SUBJECT: PERRY NUCLEAR POWER PLANT, UNIT NO. 1 - ISSUANCE OF  
AMENDMENT REGARDING TECHNICAL SPECIFICATION CHANGES TO  
PERMIT INSTALLATION OF UPPER CONTAINMENT POOL GATE AND  
DRAIN-DOWN OF REACTOR CAVITY PORTION OF UPPER CONTAINMENT  
POOL (CAC NO. MF7476) (L-16-083)

Amendment No. 174  
License No. NPF-58

SAFETY EVALUATION BY THE OFFICE OF NUCLEAR REACTOR REGULATION  
RELATED TO AMENDMENT NO. 174 TO FACILITY OPERATING LICENSE NO. NPF-58

Figure 3.10.9-1  
Upper Containment and Suppression Pool Levels

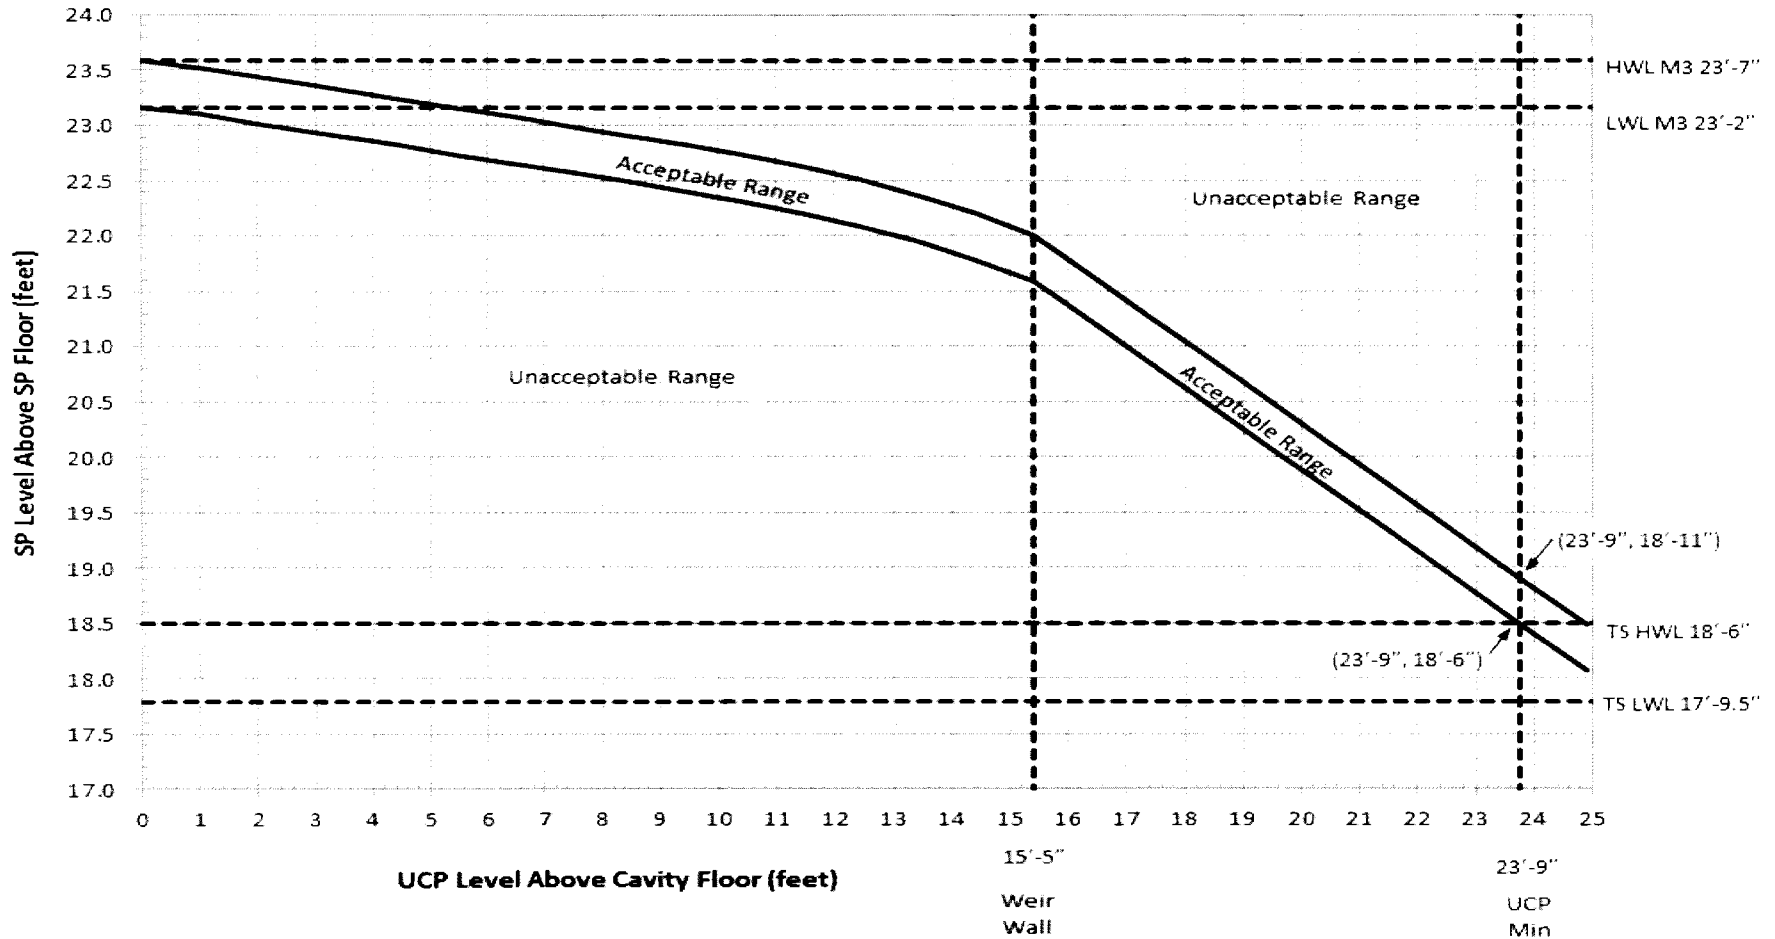
- a. Suppression pool average temperature is  $\leq 110^{\circ}\text{F}$ ;
  - b. Suppression pool and upper containment pool water levels are maintained within limits of Figure 3.10.9-1;

TS 3.10.9: The licensee proposes the creation of new TS 3.10.9, "Suppression Pool Makeup-MODE 3 Upper Containment Pool Drain-Down," including Figure 3.10.9-1, to suspend TS 3.6.2.2, "Suppression Pool Water Level," and TS 3.6.2.4, "Suppression Pool Makeup (SPMU) System," and to allow draining of the reactor well portion of the UCP in MODE 3 under certain conditions.

Figure 3.10-9-1, "Upper Containment and Suppression Pool Levels," is also added, but is not reproduced here. Figure 3.10.9-1 provides the acceptable range of suppression pool level above the suppression pool floor (in feet) as a function of UCP level above the cavity floor (in feet).

The suppression pool LWL will need to be increased by 5.4 inches + 0.3 inches (accounting for level instrument uncertainty) to a new lower limit of 18 feet 3.2 inches when the reactor well to steam dryer storage pool gate is installed in MODES 1, 2, and 3. If the MODE 3 drain-down of the reactor cavity portion of the UCP is conducted, the suppression pool LWL will need to be increased in accordance with new TS Figure 3.10.9-1.

If the MODE 3 drain-down of the reactor cavity portion of the UCP is conducted, the suppression pool HWL will need to be increased in accordance with new TS Figure 3.10.9-1.

The SRs associated with LCO 3.10.9 include verification of suppression pool temperature, reactor steam dome pressure, levels in the Acceptable range of Figure 3.10.9-1, levels in the steam dryer storage pool and the fuel transfer pool areas of the UCP are sufficiently above the reactor vessel flange, location of the IFTS carriage, and closure of the IFTS transfer tube shutoff valve.
